**Notes ID:** 8AFEFD90D12398CEC5028792216ABDD3
From: "Hallinan, Patrick J. (ECY)" <PHAL461@ECY.WA.GOV>
To: Brian Nickel/R10/USEPA/US@EPA; Ben Cope/R10/USEPA/US@EPA
Copy To: "Moore, David (ECY)" <DMOO461@ECY.WA.GOV>
Delivered Date: 05/20/2011 09:02 AM PDT
Subject: RE: Additional info needed on latest model results

2. Test_4_Equivalence_Calcs_IEP_051911.xls: Special output pasted into
Equivalence template

Test_4_Equivalence_Calcs_IEP_051911.xls:1 [Compatibility Mo...]

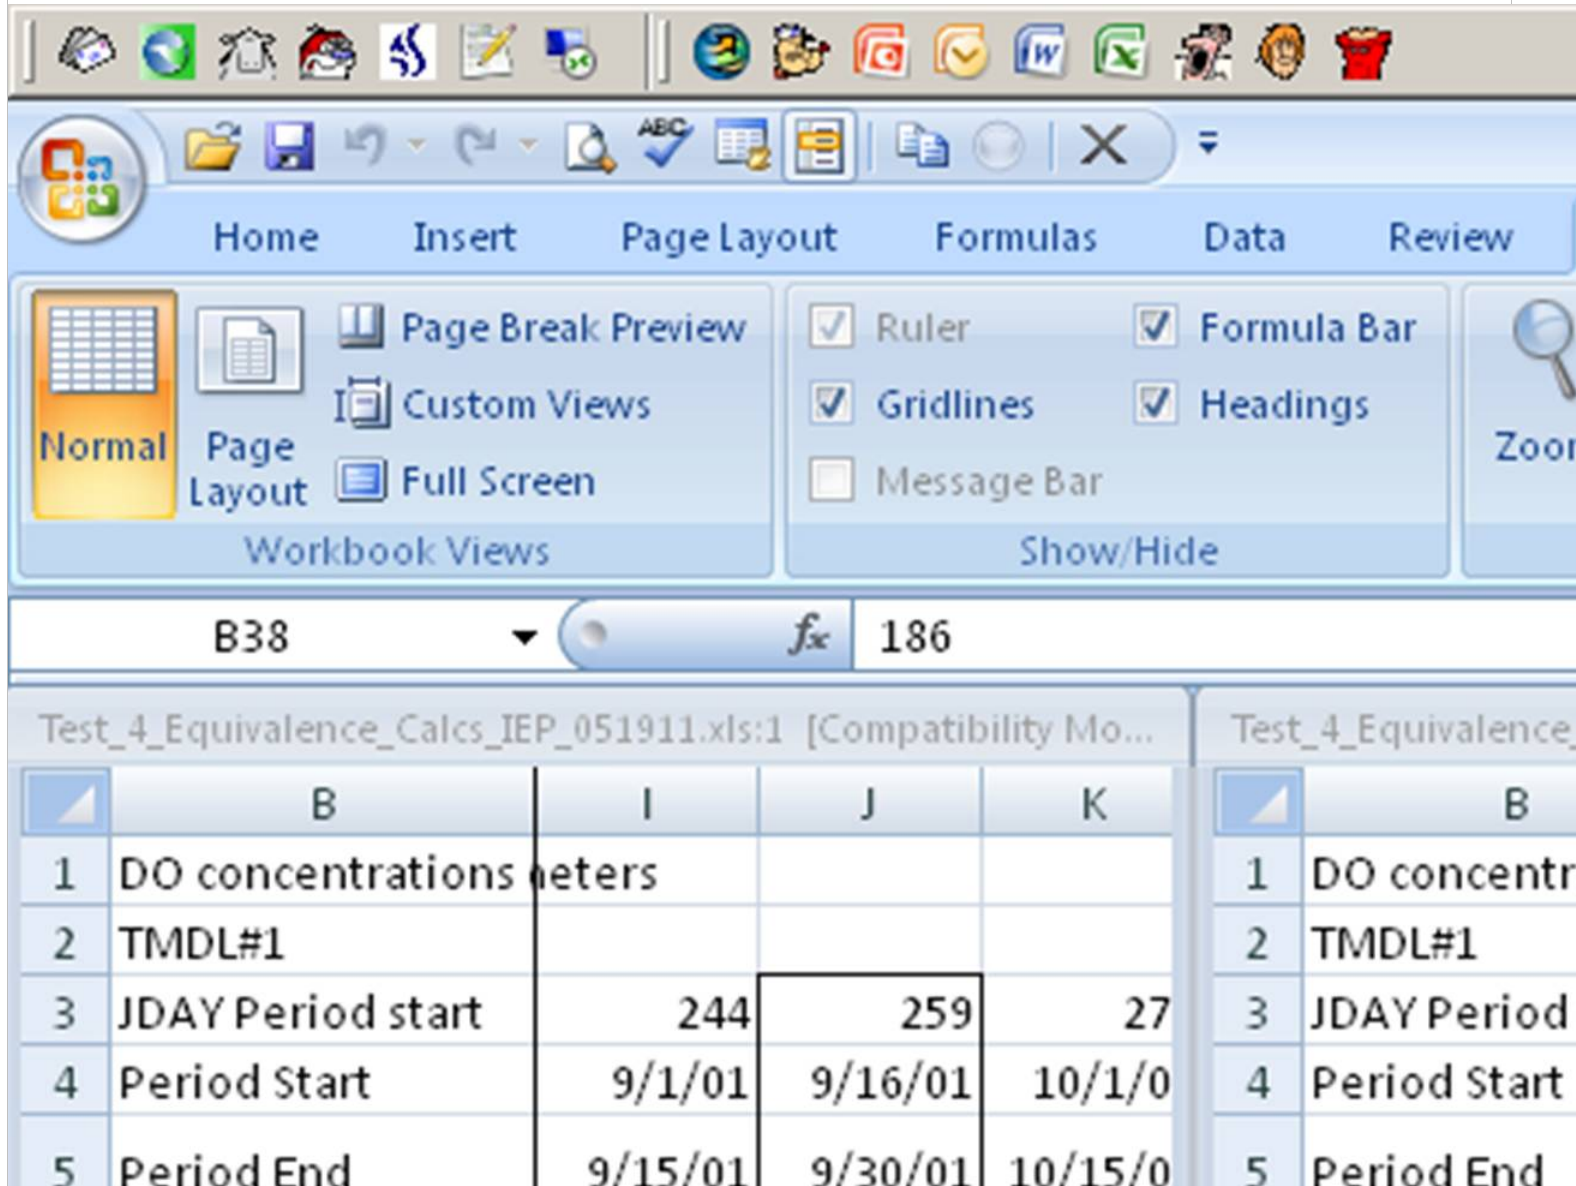
I went over the spreadsheet, and had a question on the calculations. The spreadsheet gives two TMDL#1 DO values, one from the 'nonoptimized run' in sheet 'TMDL#1 vs IEP'. I'm assuming the other values in the remaining sheets are from the optimized model?

If you look at cell 186, 9/16–9/30, the DO values differ between the two TMDL#1 runs (4.893 vs 4.8876, see below) and the calculations in sheet 'Total TMDL + IEP Delta' use the 4.893 rather than the 4.8876. Why would they use one value rather than the other?
